## REMARKS

**Please amend this application as follows:**

**In the Drawings:**

*Fig. 1*

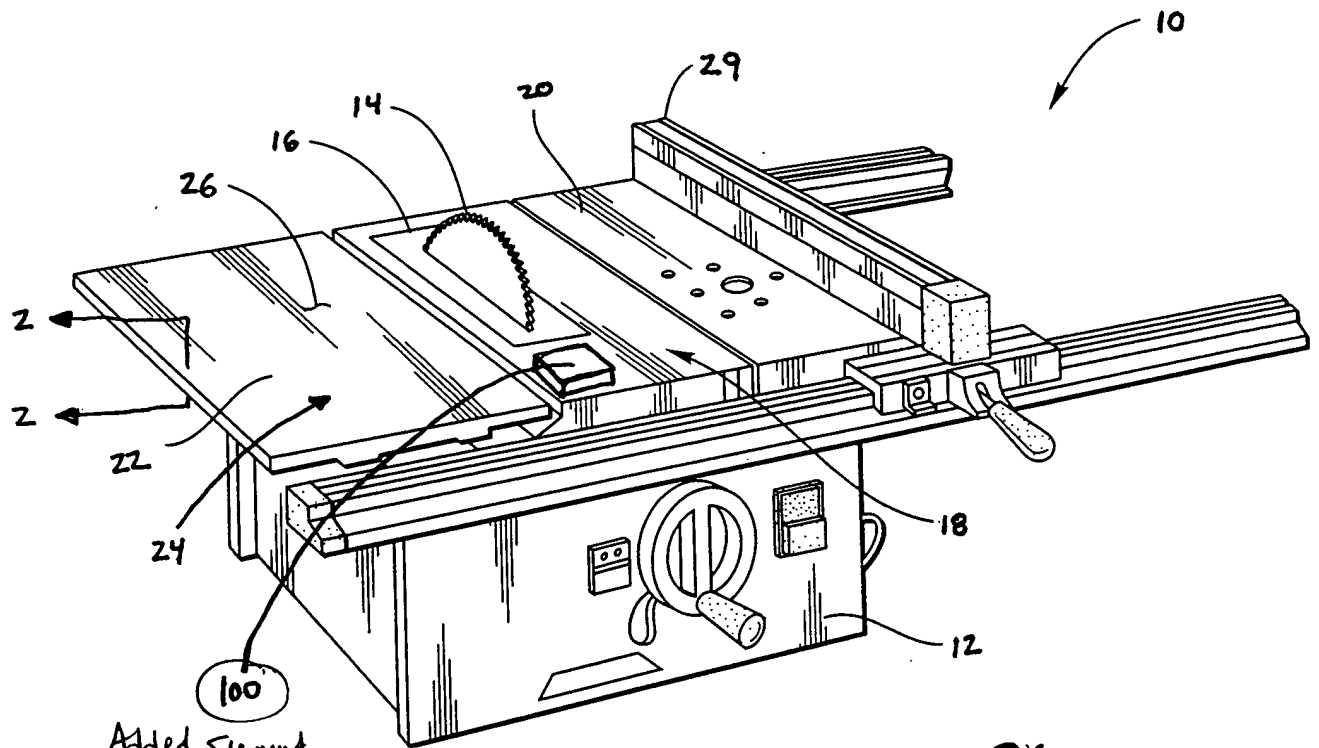
Added Element  
Number 100 and added  
a workpiece

*Fig. 3*

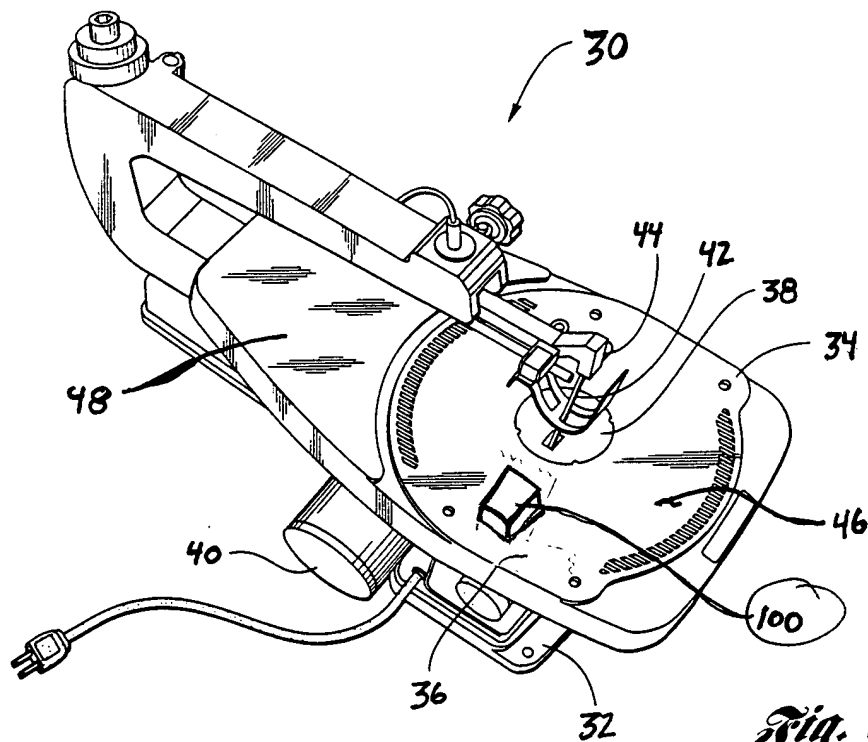
Added element  
100 and added  
a workpiece

*Fig. 4*

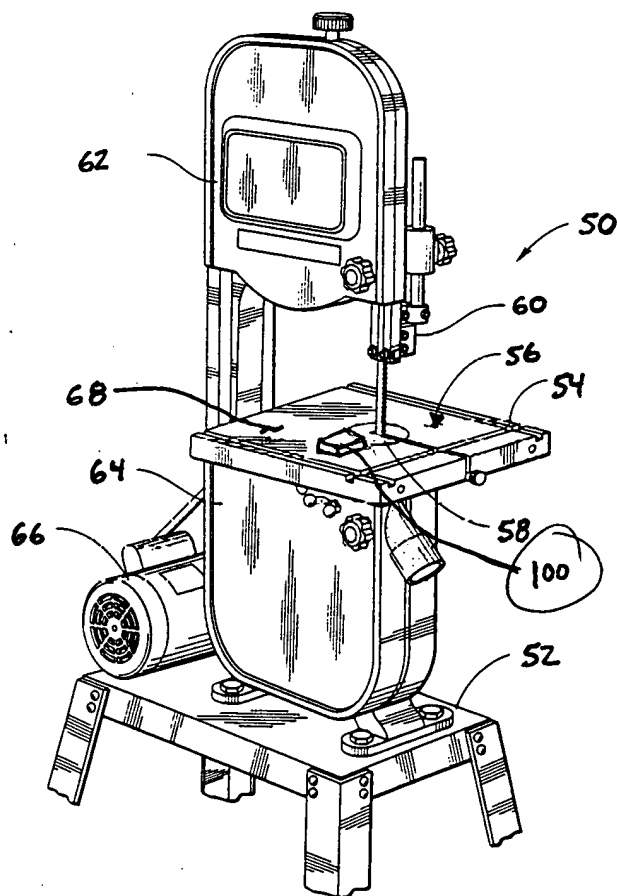
Added element  
100 and added a  
workpiece
